#06-02-32-012B: Power Steering Shudder or Vibration at Idle (Replace Power Steering Inlet (Pressure) Hose) - (Apr 12, 2007)

Models: 2005-2007 Chevrolet Corvette
with Automatic Transmission

This bulletin is being revised to add 2007 model year. Please discard Corporate Bulletin Number 06-03-32-012A (Section 02 -- Steering).

Vehicles with FE1 and FE2 Suspension

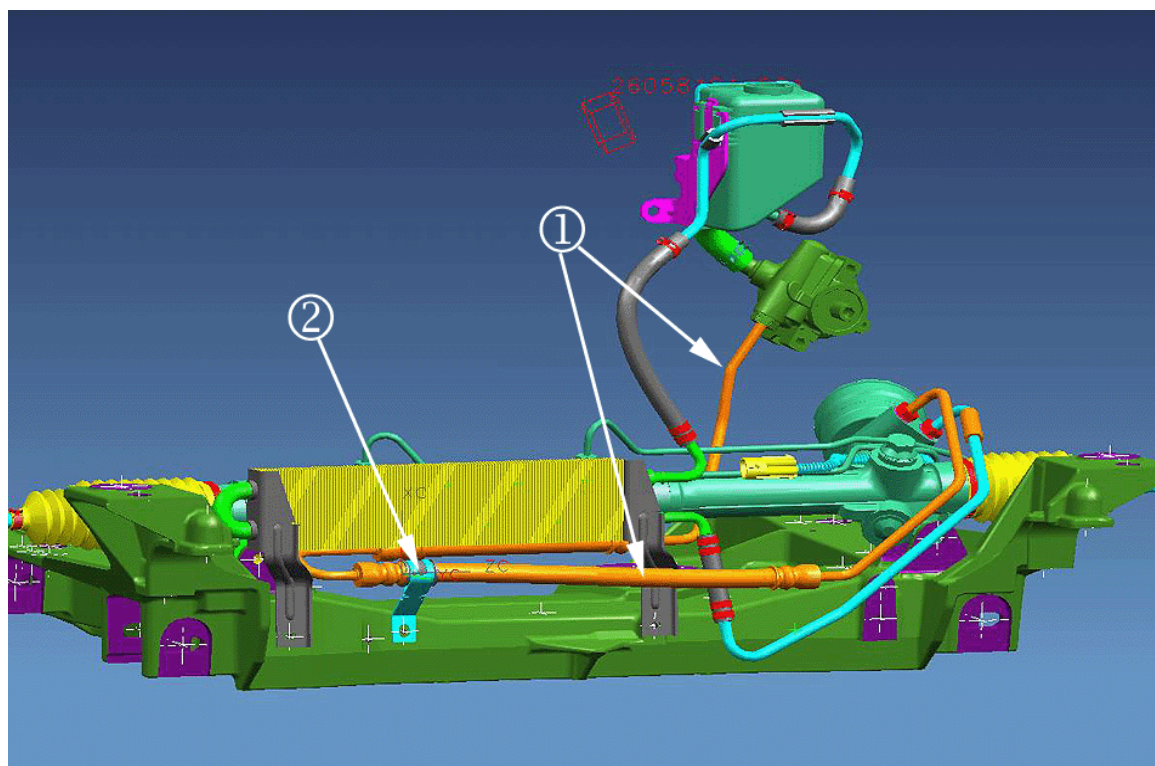
Replace the power steering inlet (pressure) hose with a revised hose. Refer to the pictures below for new hose routing.

For vehicles with either FE1 or FE2 suspension, a retaining clip, P/N 88967174, is also required. After installing the new hose (1), attach the clip (2) to the hose just before the crimp. Secure the other end of the clip to the existing power steering return line.
